REMARKS

This application has been reviewed in light of the Office Action dated June 30, 2006. Claims 21-27 and 29-38 are presented for examination. Claims 1-20 have been canceled, without prejudice or disclaimer of subject matter, and claim 28 has been canceled and its recitations incorporated into claim 21. Claim 21, 30, and 36 have been amended to define still more clearly what Applicants regard as their invention. Claims 22-27, 29, 31-35, 37, and 38 have been amended as to matters of form and/or to ensure proper claim dependency. Claims 21 and 36 are in independent form. Figures 1-9 have been canceled and Figure 13 has been amended to ensure consistency of reference numbers. Favorable reconsideration is requested.

FOR ORIGINAL FIG. 11

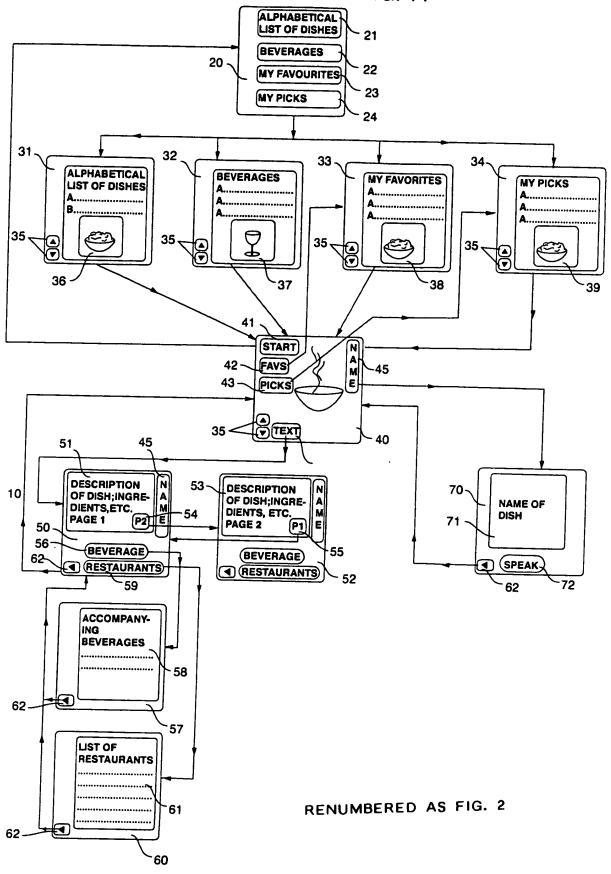
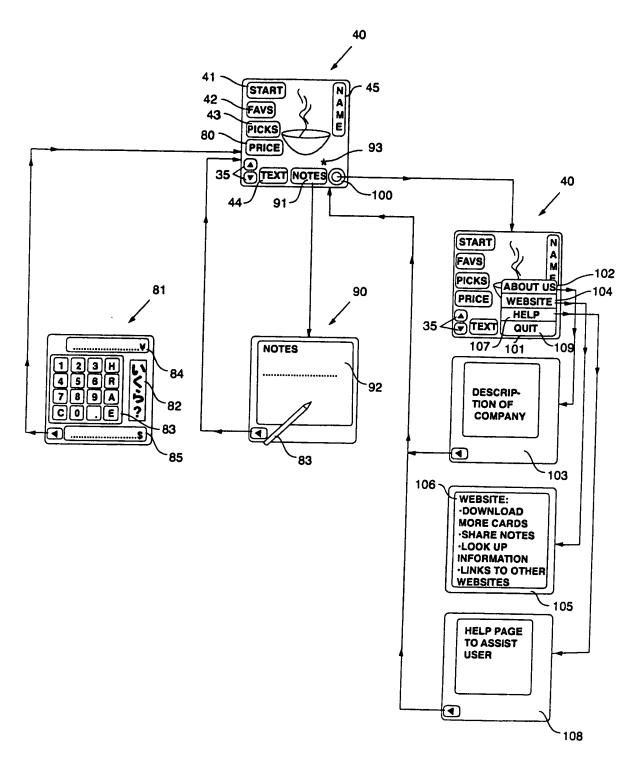
With respect to the Examiner's comment on page 2 of the Office Action that the description of the reference numbers must be directed to the same structural elements or features throughout the specification, Applicants respectfully request the Examiner provide specific occurrences where the description differs. Applicants have amended Figure 13 to ensure consistency of reference numbers.

RENUMBERED AS FIG. 3

ANNOTATED SHEET FOR ORIGINAL FIGS. 19 & 20

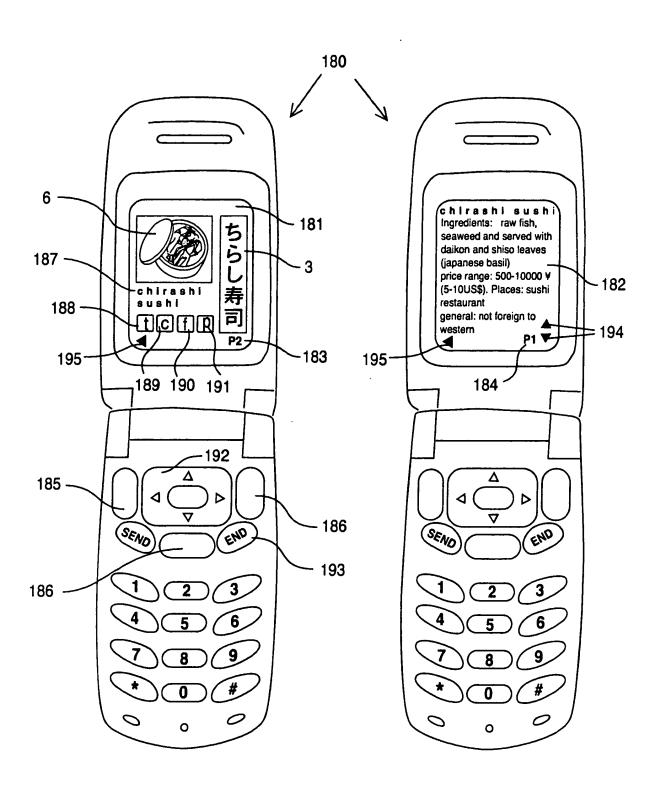
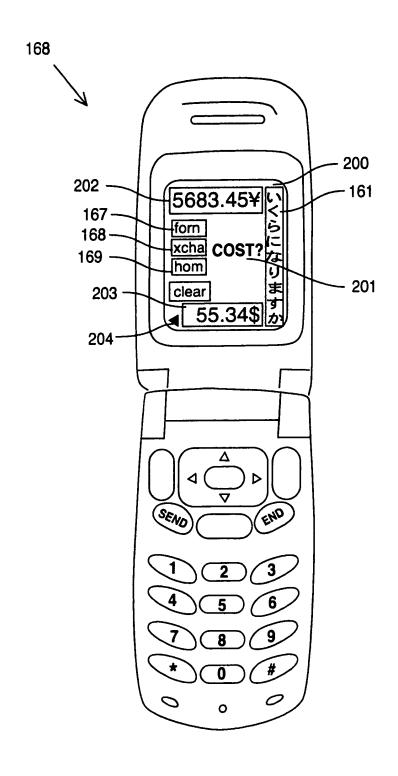
Applicants have amended the specification (refer to the Submission of Substitute Specification filed concurrently herewith) to cancel Figures 1-9 and removed reference to these figures from the Brief Description of the Drawings section of the specification. Figures 1-9, corresponding to Figures 1-9 of parent Application No. 10/144,513 which has matured into U.S. Patent No. 6,685,188, were inadvertently included in the specification of the present application. The remaining figures, Figures 10-21, have been renumbered. No new matter to the original disclosure is believed to have been added as a result of these changes.

RENUMBERED AS FIG.12
